NO: <u>07-180</u>

SUBJECT: 2006-0610 - Taylor Woodrow [Applicant] Duane Ventures

**LLC** [Owner]: Appeal of a decision of the Planning Commission approving an application for related proposals on a 7.3 acre site located at **1030 East Duane Avenue** (near Lawrence Expressway) in an MS/ITR/R-4/PD (Industrial & Service/Industrial to Residential/High Density Residential)

Motion **Vesting Tentative Map** for condominium purposes.

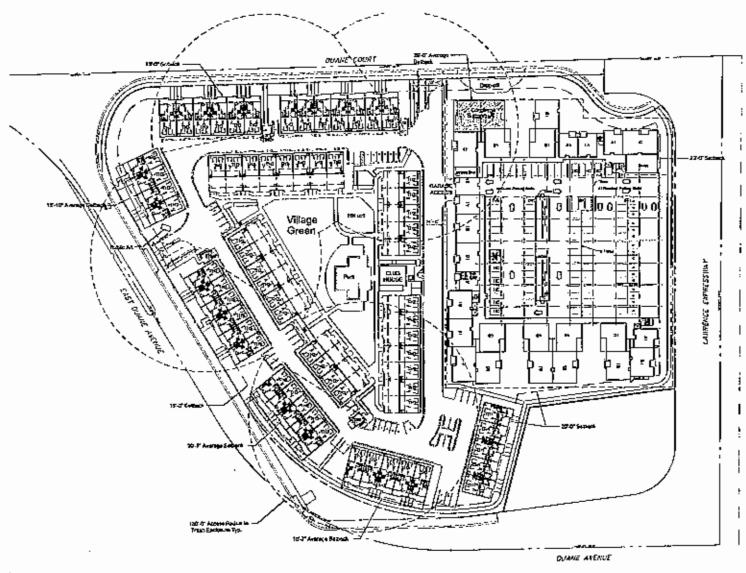
On page one of the site plans in Attachment E, there is an inconsistency in the data tables, "Unit Mix" and "Parking Summary", that creates a contradiction in the required number of parking spaces. Staff and the applicant both agree the project will provide the number of parking spaces required under SMC. Staff has included a condition of approval (1.N) to ensure the project will be compliant with SMC parking standards.

Podium Building - Typical Plan

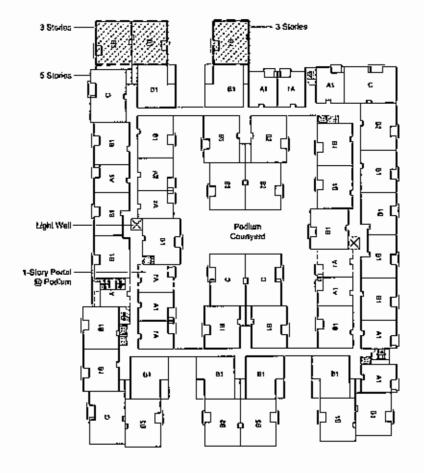
On page 11 of the site and architectural plans in Attachment E, there is an error showing one unit "C" on the ground floor facing towards Lawrence Expressway. Staff and the applicant both agree this unit is intended to face towards Duane Court. A condition of approval (1.M) has been added to correct this inconsistency.

- M. The first level condominium unit plan "C" in the northeastern most corner of the building shall have the front door facing to Duane Court, not Lawrence Expressway.

## Possible Solutions for Traffic Issues:

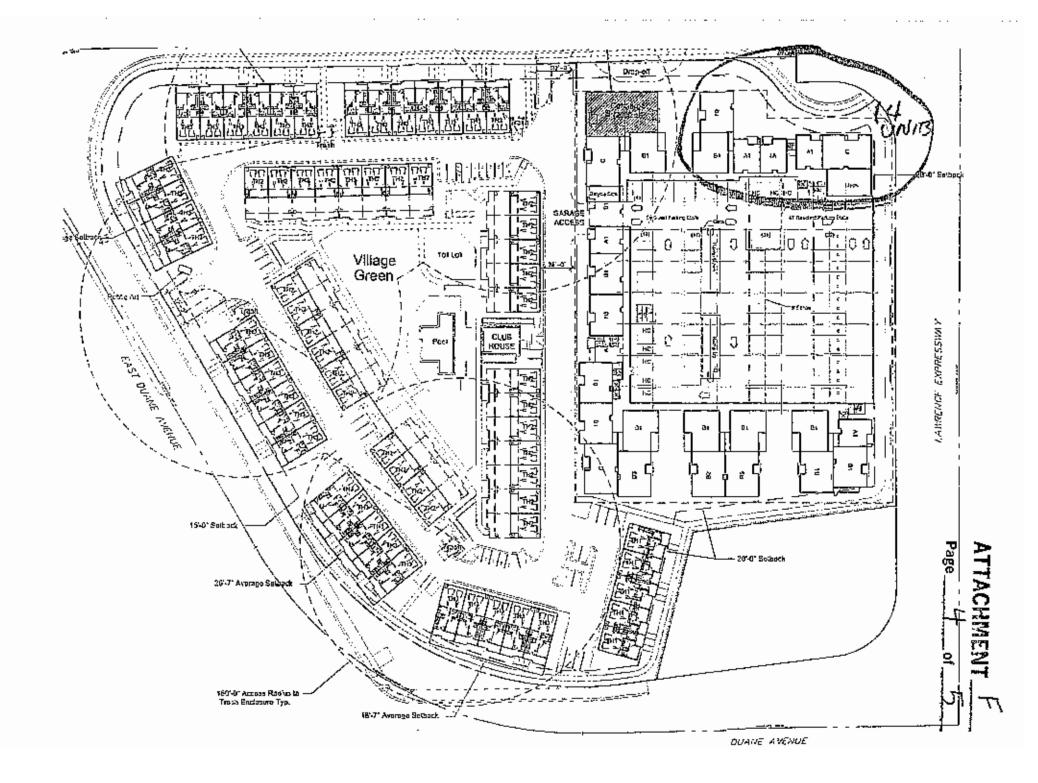
- Taylor Woodrow has identified an alternative entry-exit, closer to Duane Avenue, just past the right turn onto Duane Court. This alternative entry will keep most of the traffic off Duane Ct. This works much better for SMNA than the current entry-exit almost across from Santa Ynez.
- Taylor Woodrow also proposed an alternative exit from Duane Court which is closer to Duane Avenue. With a few adjustments, SMNA neighbors believe this will also work better.

- Block off the one-way exit from Duane Court onto Duane Avenue and make this essentially a private street.
- Where the left turn lane is from Duane Court onto Duane Avenue have two lanes instead of one. So there would be separate left turn and right turn lanes as well as one entry lanes
- If there are still issues after the development is built then we could look at options like blocking off Santa Ynez to right turns from Duane Court and the possibility of a traffic signal.
- A few years ago, the Duane-to-Fair Oaks signal was modified to single lane traffic with a middle turn lane, SMNA believes this could also work with the East Duane Avenue-to-Lawrence access, AND we would have some bike lanes, too!

## SITE SECTION A

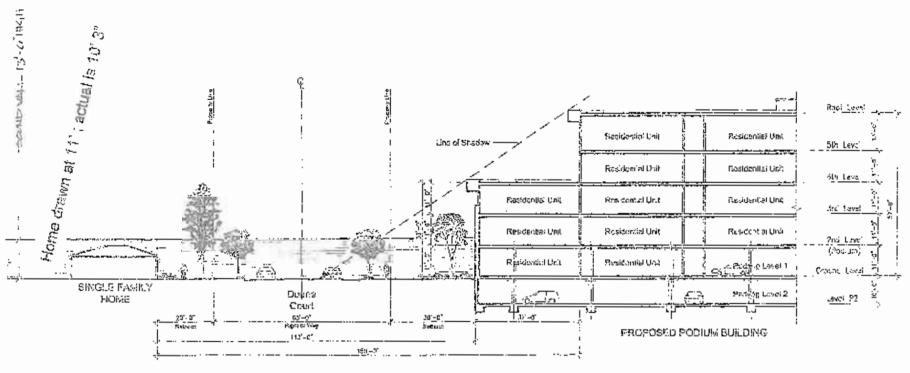
Homes 10' 3" tall directly across Duane Court from 5 story units at 57"

13' 8" Sound wall divides Duane Court from Lawrence Expressway

3 story homes above sound wall are across Lawrence Expressway Photo taken ~160 feet from sound wall on Duane Court
